Wisconsin Department of Transportation

Proposal #32: 1180-44-70, WISC 2023116
Odanah - Saxon
Government rd – East County Line
USH 2
Ashland & Iron County

This is Addendum No. 01, which provides for the following:

Addendum No. 01
 ID 1180-44-70
 Revised Sheet 50
 December 6, 2022

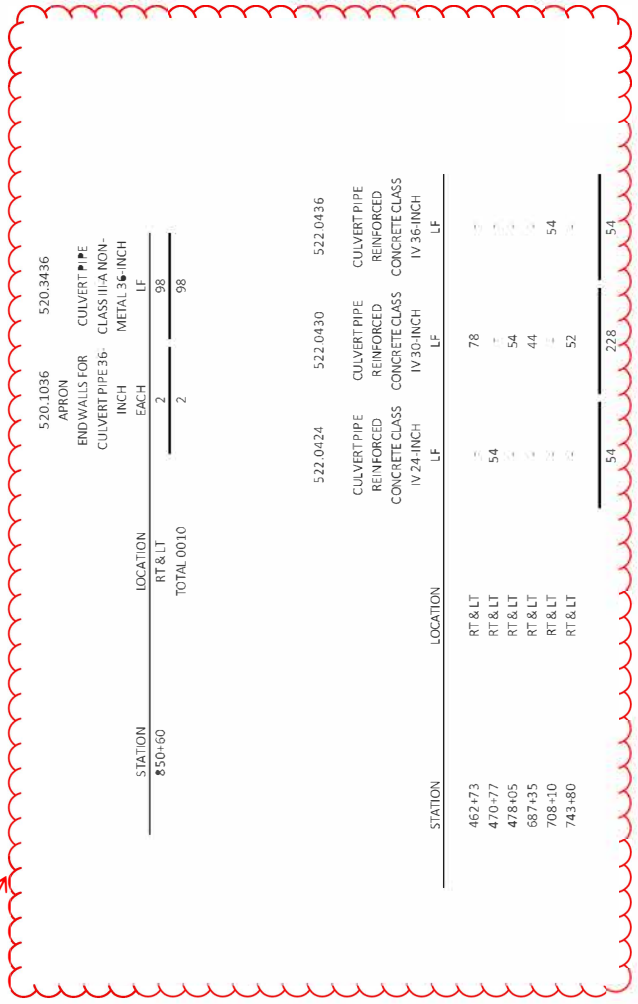
Revised Plan Sheets	
Plan Sheet	Plan Sheet Title (brief description of changes to sheet)
50	Added two new mis quantities tables with items 520.1036, 520.3436, 522.0424, 522.0430, and 522.0436
51	Removed miscellaneous quantity tables for items 522.0124 and 522.0136. Reduced quantity for items 522.0130 and 522.1030. Moved item 522.1036 from sheet 52 to this sheet
52	Moved item 522.1036 from this sheet to sheet 51 and reduced the quantity
59	Reduced the quantity for item 646.1020
60	Removed table for item 646.4520 and 649.0105 and added a table for item 643.3120 and 643.3105
63	Updated quantity and changed the pipe from class III to class IV concrete at the following stations: 462+73, 470+77 and 478+05
67	Updated quantity and changed the pipe from class III to class IV concrete at the following stations: 687+35 and 708+10
68	Updated quantity and changed the pipe from class III to class IV concrete at station 743+80

New Bid Item

STATION	LOCATION	LF
520.1036	APRON	520.3436
END WALLS FOR CULVERT PIPE		
CULVERT PIPE 36- CLASS III-A NON-		
INCH METAL 3/8 INCH		
EACH		98
TOTAL 0010		98

Addendum No. 01
ID 1180-44-70
Revised Sheet 59
December 6, 2022

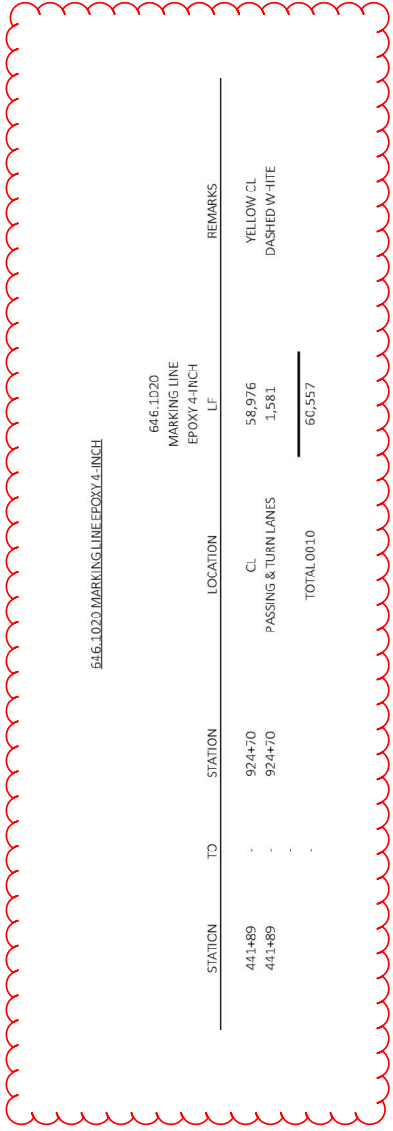
Reduced Quantity

STATION	TO	STATION	LOCATION	LF	REMARKS
441+89	-	924+70	CL	58,976	YELLOW CL
441+89	-	924+70	PASSING & TURN LANES	1,581	DASHED W-HITE
			TOTAL 0010	60,557

Addendum No. 01
 ID 1180-44-70
 Revised Sheet 70
 December 6, 2022

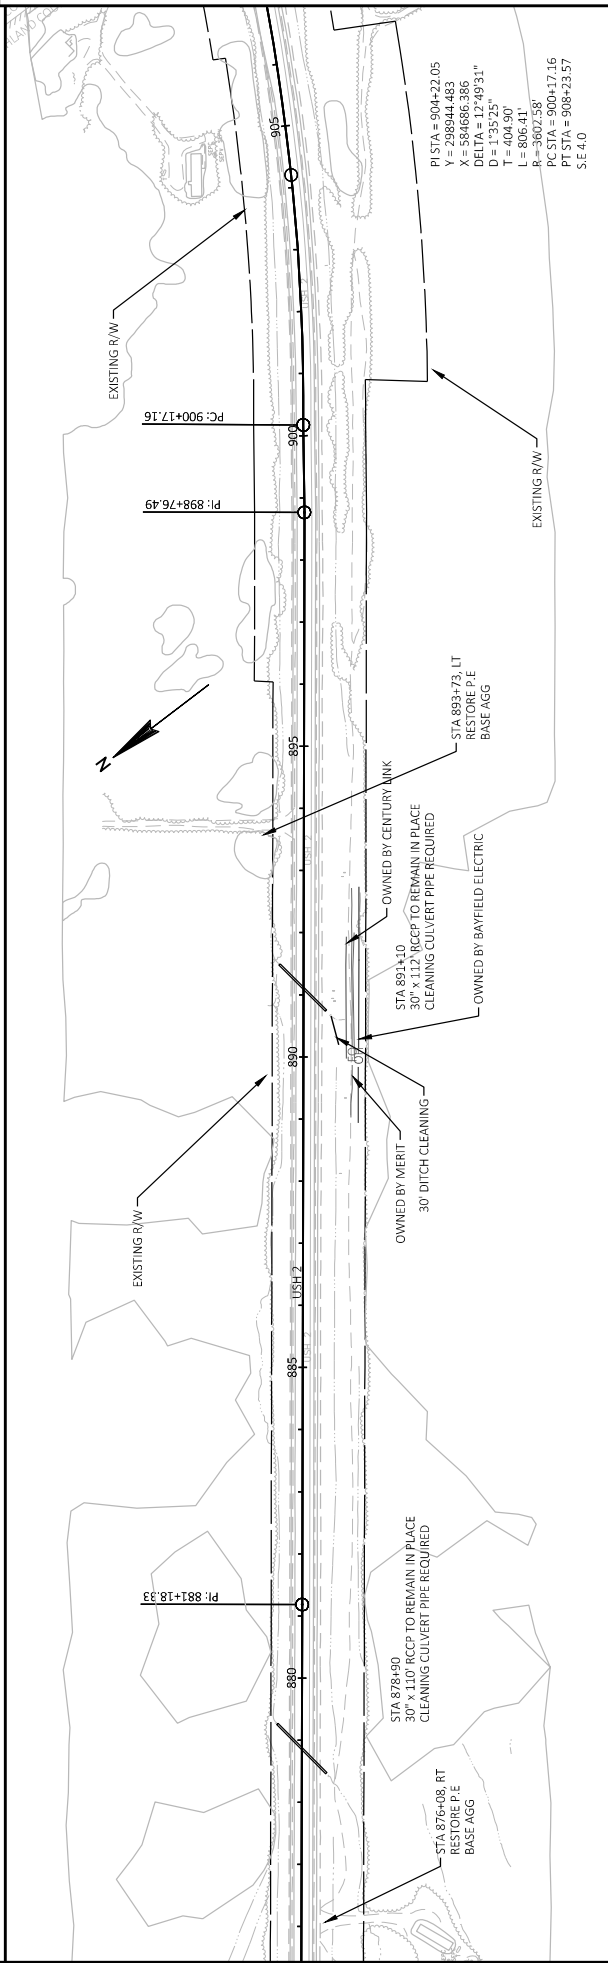
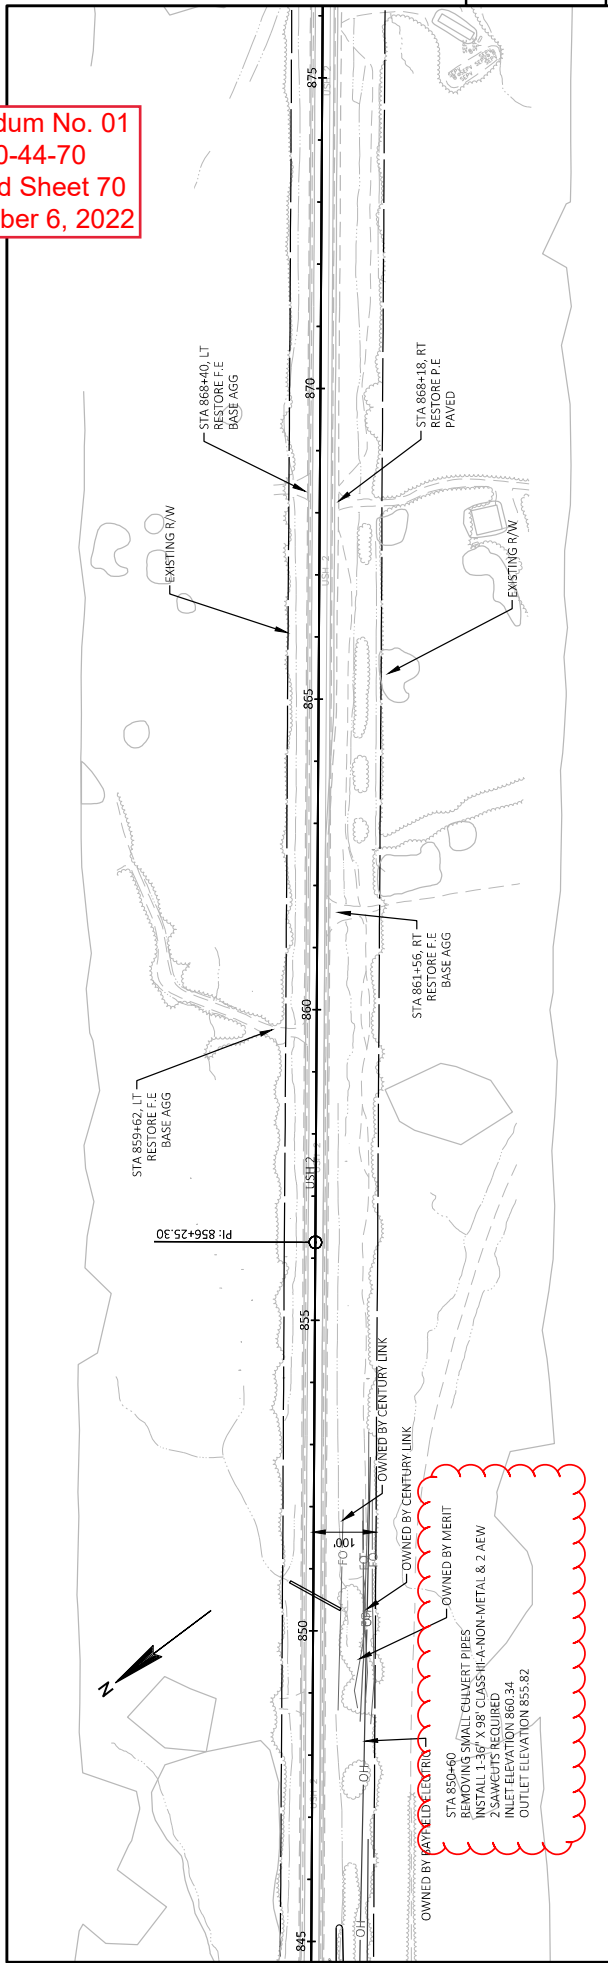
70	Changed culvert pipe at station 850+60 from class II concrete to Class III-A-Non-Metal
